CHESTER TERRACE RETAINING WALL REMEDIATION STRUCTURAL REVIEW

Project name **Chester Terrace Wall Remediation – Structural Review**
Project no. **1620012XXXX**
Recipient **Nick Packard <Nick.Packard@cepc.org.uk>**
Document type **Structural Report**
Version **Rev01**
Date **13/08/2021**
Prepared by **Scott Brookes**
Checked by **Jackie Heath**
Approved by **Jackie Heath**
Description **Structural assessment and review of current remedial strategy**

Ramboll were asked by Nick Packard of the Crown Estate Paving Commission (CEPC) to carry out a 3rd party engineering review of the assessments and recommendations made with respect to the failing retaining wall along Chester Terrace, predominantly by engineering consultants Hurst, Pierce & Malcolm (HPM).

Figure 6 Existing Retaining Wall Section © Hurst, Pierce & Malcolm

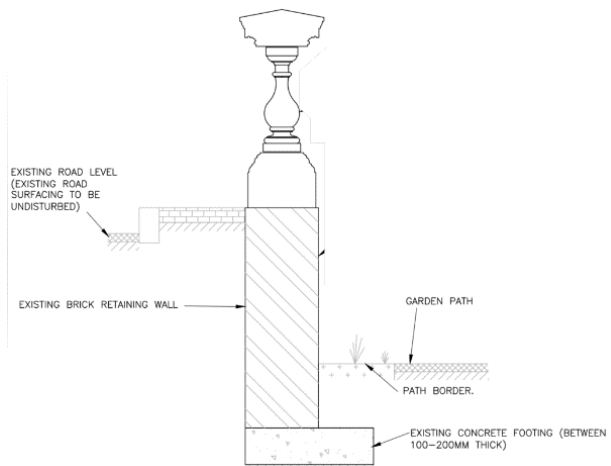
The existing footing bears onto the made ground at a depth of 0.35-0.55 metres. Our assumption is that the retaining wall is positioned centrally to the footing width and this is less conservative than the HMP assumption shown in figure 6. This needs to be confirmed via probing or a trial hole.

1. Confirm the size of the heel of the retaining wall through trial pitting/probing, to avoid the need for conservative assumptions about the footing width. Carry out analysis ahead of time to determine required footing width threshold.
2. Change TEDDS retaining wall analysis criteria from 'cantilever' retaining wall to gravity
3. Report on the extent or factor to which the retaining wall fails at each trial pit location by 1) overturning and 2) sliding respectively, to steer remedial need at each section of wall

Figure 15 Section 7 -Option 1: Only cosmetic repairs to the retaining wall. No in-situ strengthening or tying of retained elements.

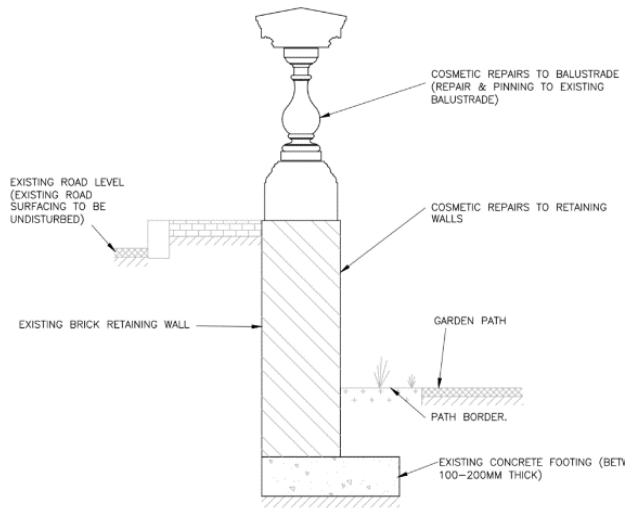
HPM has proposed four repair options within their reporting, with varying degrees of efficacy, disruption and associated cost:
